## CENTRAL AREA COMMITTEE MEETING 09-07-19

**PLAN NO:** PLANNING REF. NO. 2774/19

**LOCATION:** PROPOSED IMPROVEMENT WORKS TO LIFFEY STREET UPPER & LOWER, DUBLIN 1.

Proposed plan of Liffey Street Lower

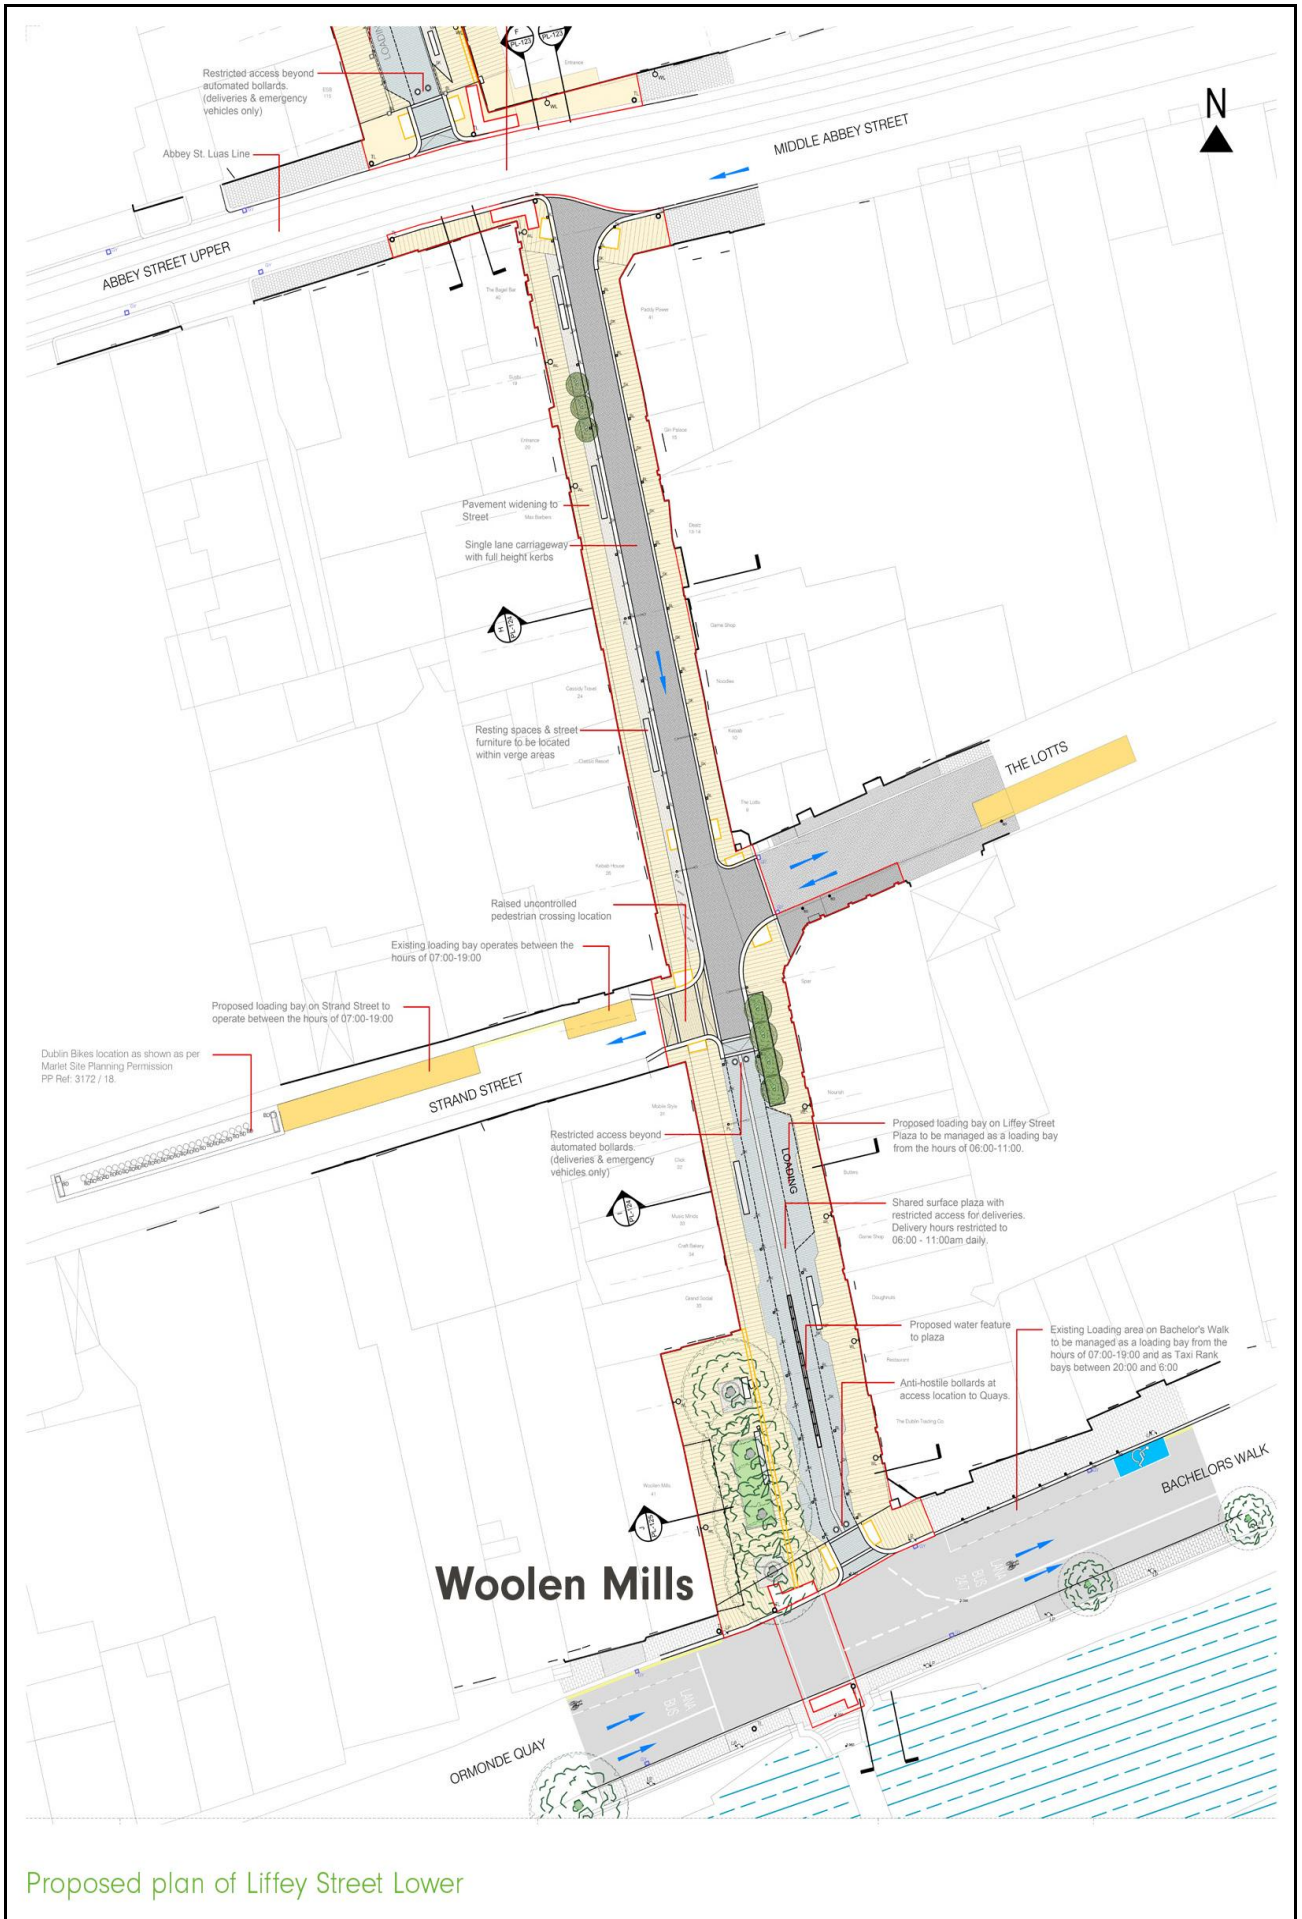
Niall O' Byrne (on behalf of Balark Trading GP Limited), welcomed the proposed development but requested that the positioning of loading bays on Strand Street be examined as part of the detail design.

The proposed water feature is considered to be visually incongruous with the surrounding area as well as potentially impeding to the movement of pedestrians. It is recommended that as part of the detail design of the proposed scheme, the proposing department should consider the omission of this element.

Concerns have been also raised in relation to the location of loading bay upon Great Strand Street and the potential conflict with recently permitted developments in the area. The relocation of the loading bays on Strand Street will be considered as part of the detailed design stage and therefore it is recommended that this be explored by the design team.
